Access Compliance Report Public Rights-of-Way (Curb Ramps)

Main Street: CRESTWOOD_LN Cross Street: S_BROOKHURST_ST Location: NW

ADA ID: RPAT220202111306 Ramp Type: Type 1 - Perpendicular Initial Pass/Fail: Pass Overall Compliance: No Severity Score: 0

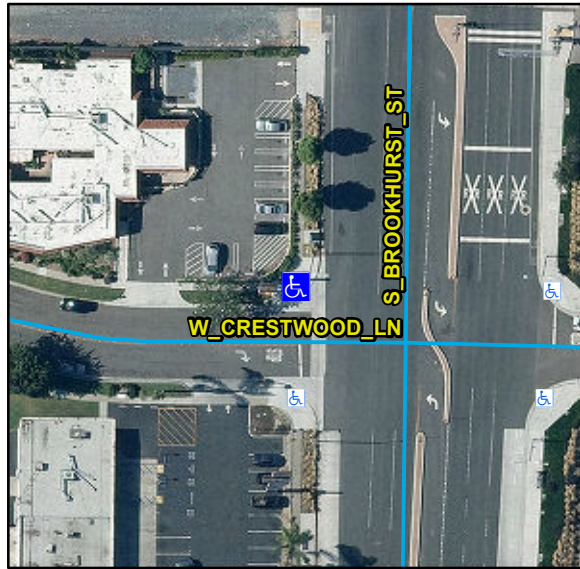
Compliance	Description	Data	Compliance	Description	Data
N/A	Ramp Length (in)	85	N/A	Flare Type LT	
Yes	Ramp Width (in)	48			Sloped
Yes	Ramp Run Slope (%)	6.6	Yes	Flare Slope LT (%)	5.8
Yes	Ramp Cross Slope (%)	1.1	N/A	Flare Traversable LT	Yes
N/A	Landing Present	Yes	N/A	Flare Type RT	
N/A	Landing Length (in)	49			Sloped
Yes	Landing Width (in)	48	Yes	Flare Slope RT (%)	6.1
Yes	Landing Run Slope (%)	1.6	N/A	Flare Traversable RT	Yes
Yes	Landing Cross Slope (%)	1.1	Yes	DWS Provided	Yes
N/A	Landing Movement Obstructed?	Yes	Yes	DWS Contrast	Yes
	Landing Movement Type	Curb	Yes	DWS Length (in)	36
N/A	Landing Shared	Yes	Yes	DWS Full Width	Yes
N/A	Clear Space	N/A	Yes	DWS Offset Left (in)	0
N/A	Clear Space To Crosswalk (in)	N/A	Yes	DWS Offset Right (in)	N/A
N/A	Marked Crosswalk 1	No	N/A	Marked Crosswalk 2	N/A
	Crossing 1 Direction	S		Crossing 2 Direction	N/A
	Marked Crosswalk 1 Width (in)	N/A		Marked Crosswalk 2 Width (in)	N/A

Remove & Replace Landing.

R304.2.1, STD 1115
